UNITED STATES ENVIRONMENTAL PROTECTION AGENCY

Re: *Draft Source Investigation Report, Site 9 Neptune Drive Disposal Site*
Brunswick Naval Air Station

The following are the EPA's review comments on the report titled *Draft Source Investigation Report, Site 9, Neptune Drive Disposal Site* dated February 1996.

ABB ABB Environmental Services, Inc. INSTALLATION RESTORATION PROGRAM NAVAL AIR STATION BRUNSWICK, MAINE	INTERPRETIVE GROUNDWATER CONTOUR MAP: SITE 8
	SOURCE INVESTIGATION 48-07-08-09 FIGURE 5-1

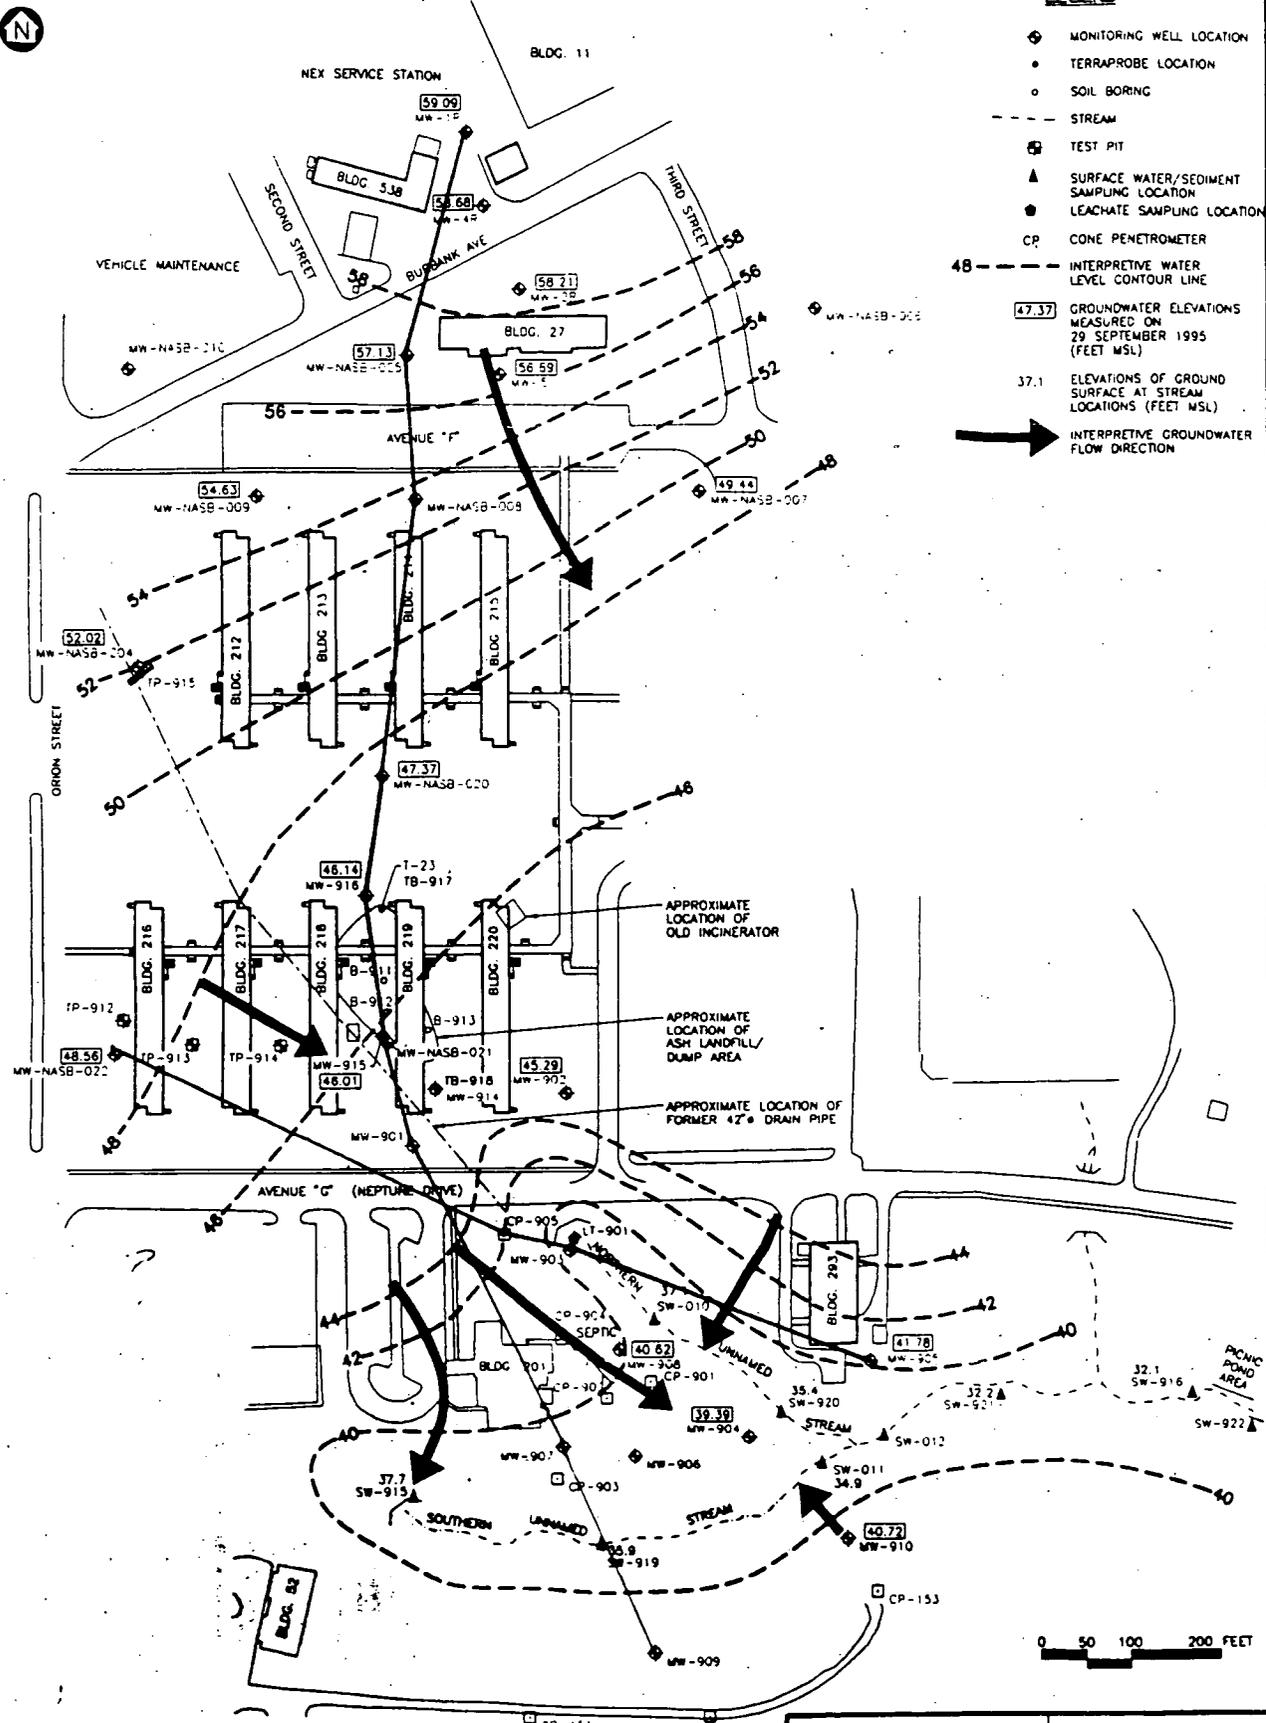
1. The report requires some additional background on the site geologic and hydrologic characteristics, so that the potential contaminant migration pathways and potential source areas as stated in the report can be reviewed. For example, the aquifer characteristics (unconfined versus confined) need to be addressed in relation to the reported information that indicates that wells in close proximity to each other (e.g., MW-915 and NASB-21) have piezometric elevation differences of about 1 foot (see Table 5-4). Also many of the wells have a dark blue clay layer at about 20 to 25 feet below ground surface dividing gray fine sands. The implications of this clay layer on the distribution of contaminants throughout the site should be discussed. It is suggested that an east-west and north-south representative geologic cross-section of the site should be included in the report (See attached map for suggested locations).

4. The report summarized the characterization results of potential contamination sources immediately north and northwest of the wells in which vinyl chloride has been detected. However, Figure 5-1 of the report indicates that the flow of groundwater in the area of Buildings 216 through 220 is predominantly from the west. Although monitoring wells, MW-NASB-204 and MW-NASB-022, and test pits, TP-912 and TP-915, did not detect any VOC contamination, the report should include a discussion of whether or not further investigation of the area west of the site, as a source of the VOC contamination, is necessary. The consistent, relatively low vinyl chloride concentrations detected in the

wells at Site 9 may indicate that the contamination is the leading edge of a plume. The Site 9 VOC contamination should be evaluated from a regional perspective in relation to both regional groundwater flow and potential source areas.
